W-REF: P24-128
5 August 2025

Memorandum

Milldale Fast-track – 4C – Response to council feedback

2. Long sections & Visibility and Swept path assessments (Auckland Transport & Planning Memo Item 32)

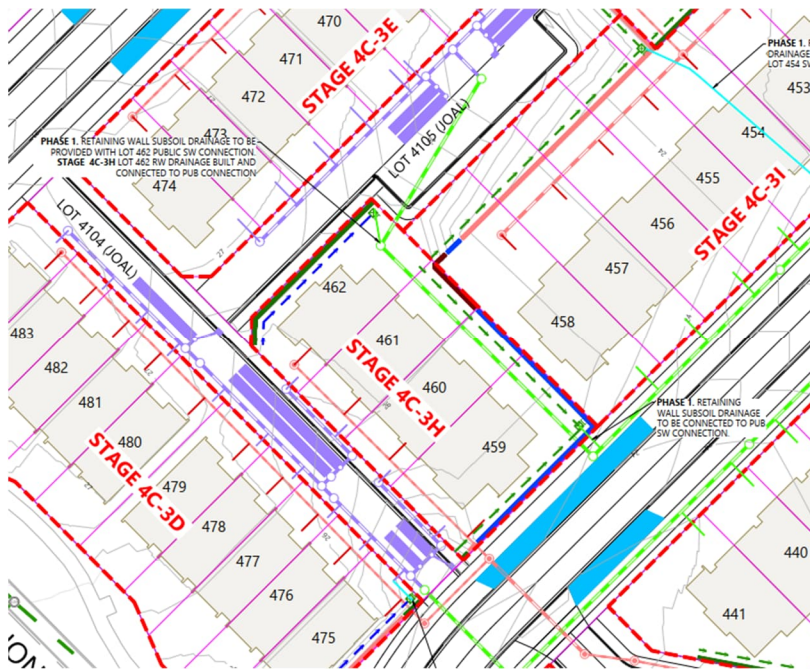
Auckland Transport have raised concerns that long sections have not been provided and that a swept path or visibility assessment has not been undertaken for the proposed design. Similar concerns have been raised in Auckland Council's Transport assessment.

While this information has not been provided for council review, the swept path and visibility assessments have been considered as part of the proposed design. Milldale 4C has a fairly typical set of tee-intersections with relatively flat geometry. Woods are very familiar with these intersection designs in the Milldale context and have undertaken sufficient design checks to ensure that the proposed intersection design and associated boundaries are sufficient to achieve the required design standards.

Full details of the proposed long sections, visibility checks and swept paths will be provided at detailed design stage. This is in line with previous consents granted for the Milldale development. It is acknowledged that if challenges are identified later in the detailed design phase that changes to the consented boundaries may be required.

4C-3H

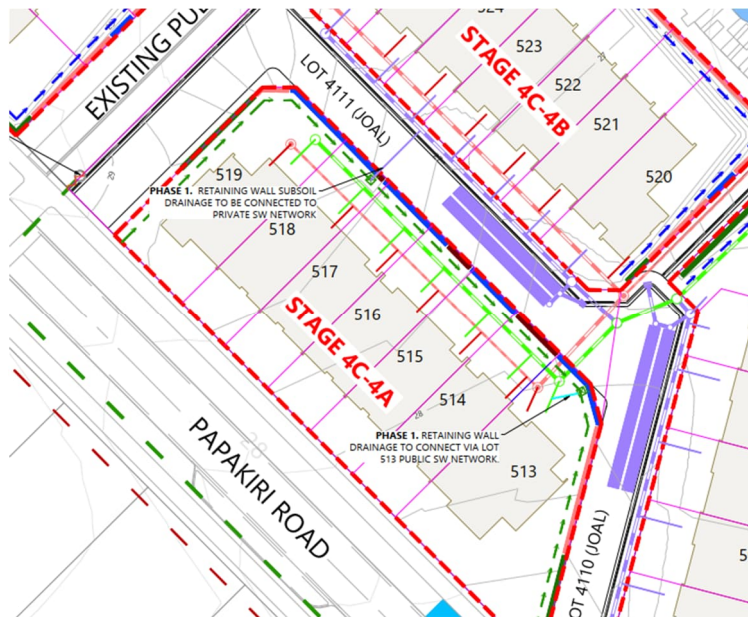
Healthy waters have raised concerns with the proposal to locate public infrastructure in the rear of properties and asked for the stormwater drainage to be realigned, noting this creates a maintenance and renewal issue for Council (Annexure A2). They have identified this as an EP matter.

The presence of public stormwater networks in the rear of proposed lots occurs in two locations in Stage 4C; through the rear of Stage 4C-3H, and along the top of the wall in the rear of Stage 4C-4A.

The public line is required to collect the stormwater from JOAL 4105. This JOAL presents design challenges from a stormwater perspective as it falls towards the northeast. It is possible to change the alignment of the public line to run back up through JOAL 4105, and then down through JOAL 4104. This will result in a reasonably deep line as it needs to run against the grade of the JOAL, but is feasible.

8. Lighting plans for shared driveways (Planning Memo Item 35)

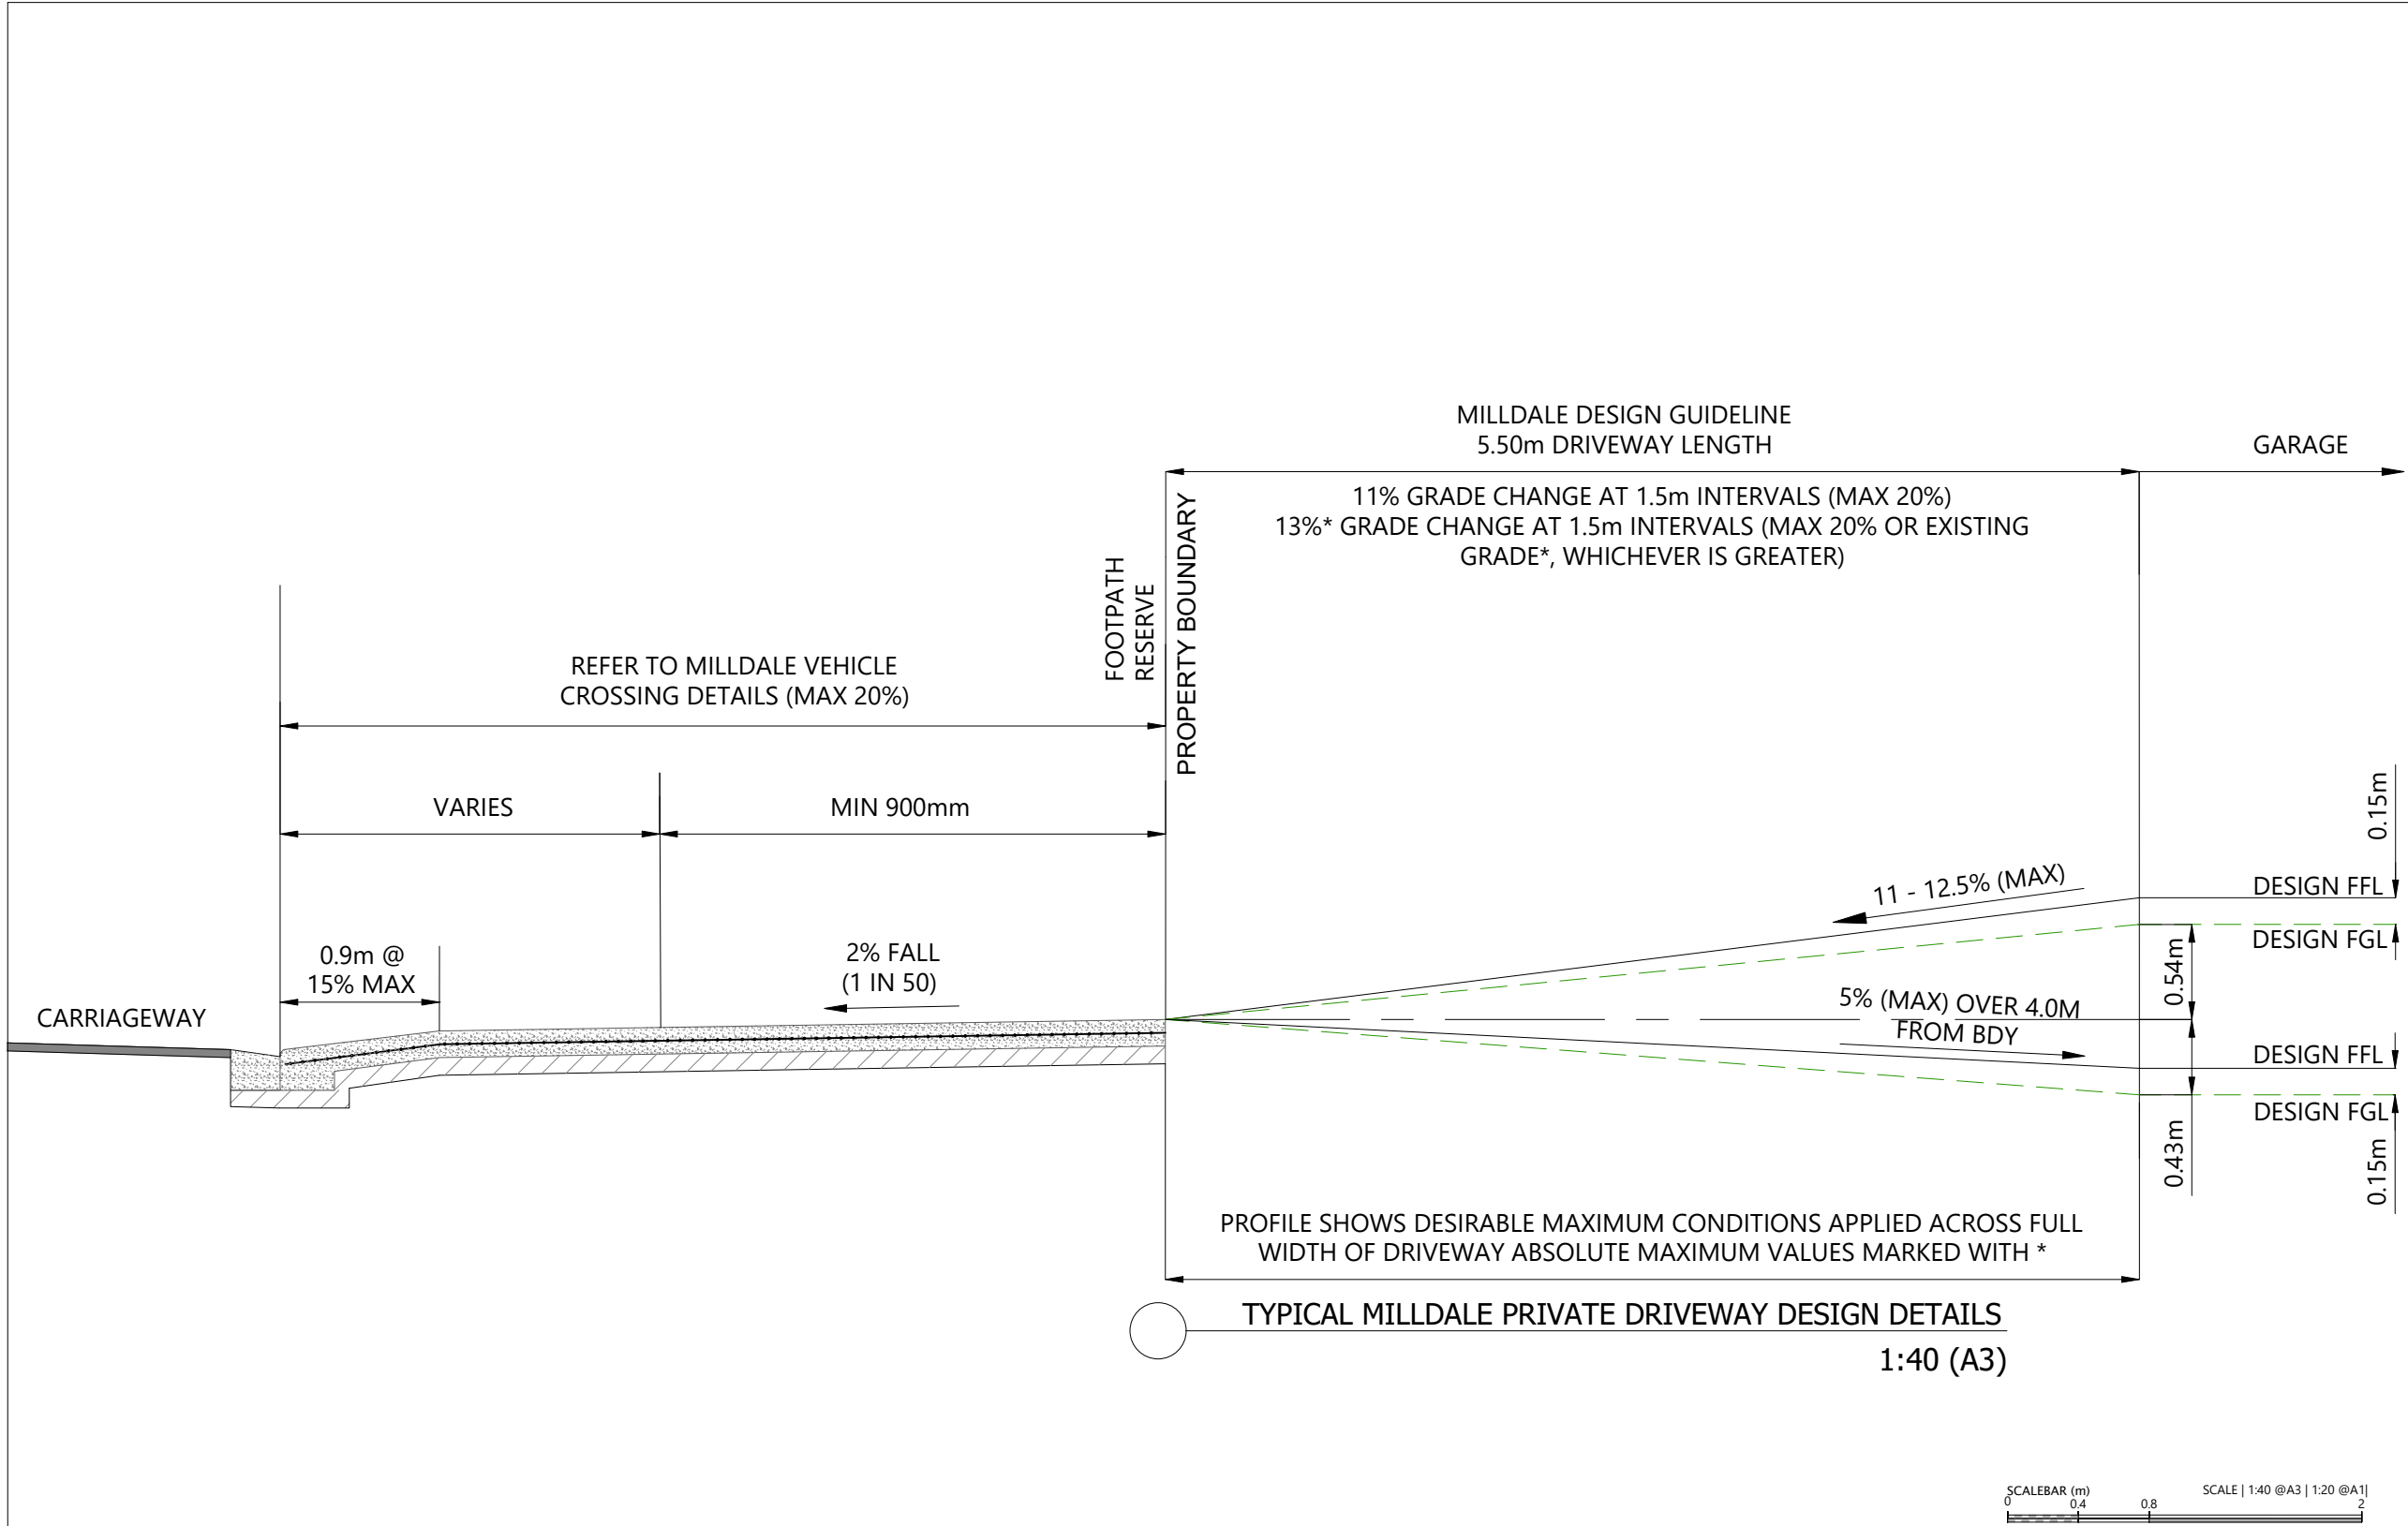
In the Auckland Council Planning Memo, it is noted that the application has not provided lighting designs for shared driveways (Item 35).

This statement in the planning memo is incorrect, a full lighting design was provided as part of the 4C application. The lighting design will be further reviewed through detailed design and an updated version will be provided as part of the EA process.
